**SUSQUEHANNA STEAM ELECTRIC STATION
PROPOSED CHANGE TO WATER TREATMENT
INFORMATION CONTAINED IN THE RENEWAL
APPLICATION FOR THE SSES NPDES PERMIT
PLA-5310**

**Docket Nos. 50-387
and 50-388**

SUSQUEHANNA STEAM ELECTRIC STATION
WATER TREATMENT CHEMICAL UPDATE
NPDES PERMIT NO. PA 0047325
CCN 741326 FILE R9-8A
PLE-0022311

7. Line Drawing. See instructions

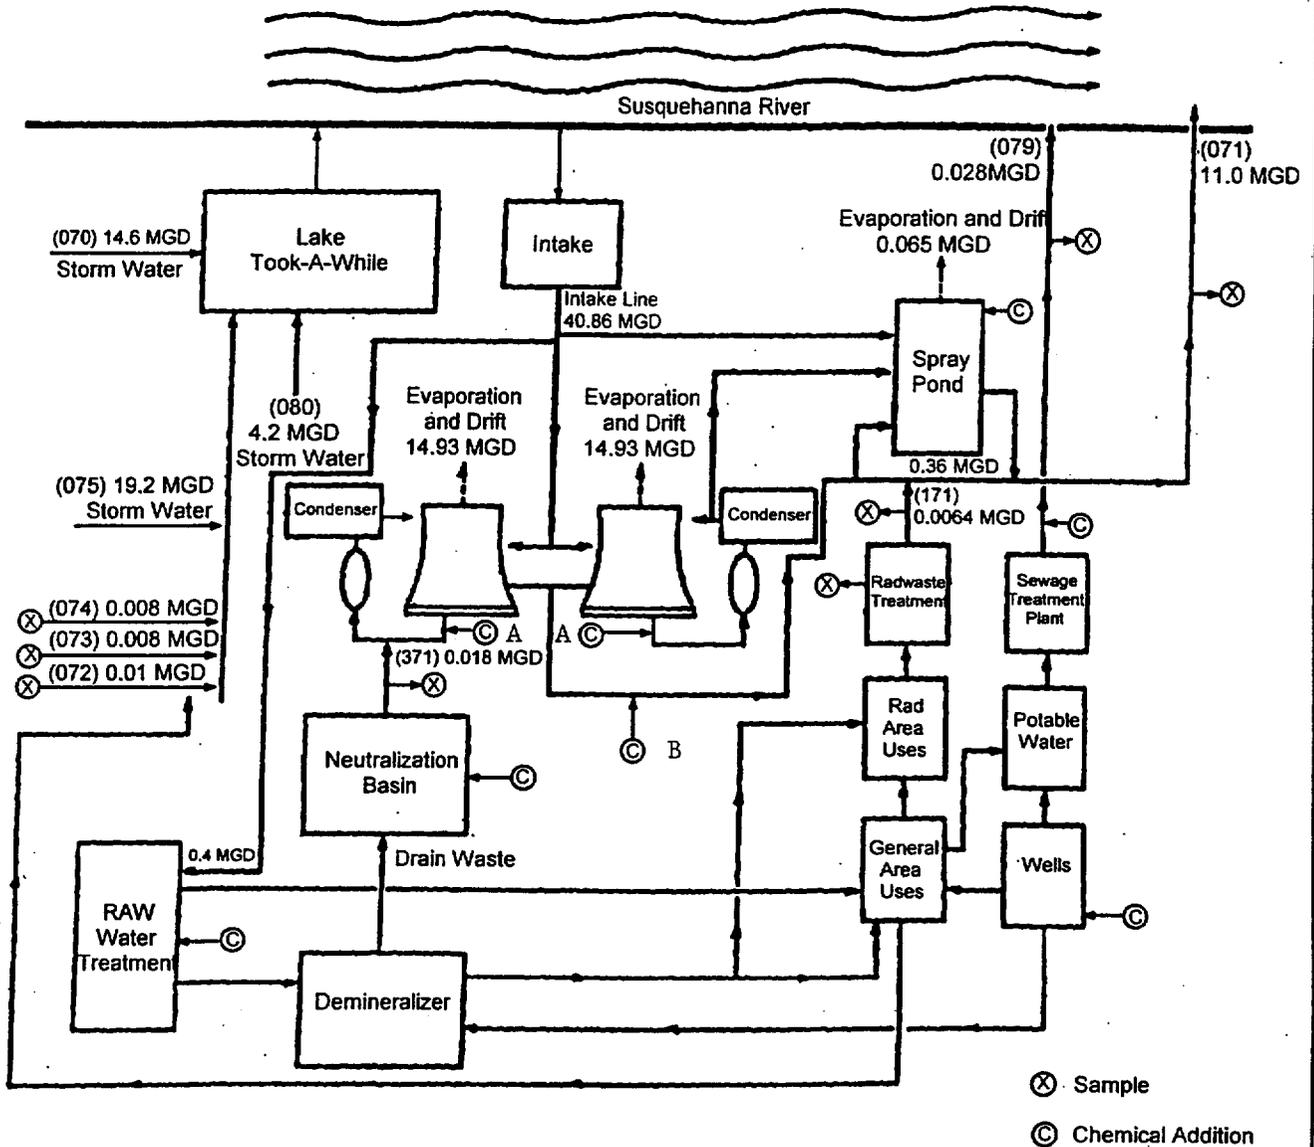
See Figure 1, Flow Diagram for location of chemical addition and discharge through Outfall 071, Cooling Tower Blowdown

See Figure 1, Flow Diagram for location of chemical addition and discharge through Outfall 071, Cooling Tower Blowdown

A Spectrus CT1300 Injection
 B Spectrus DT1400 Injection
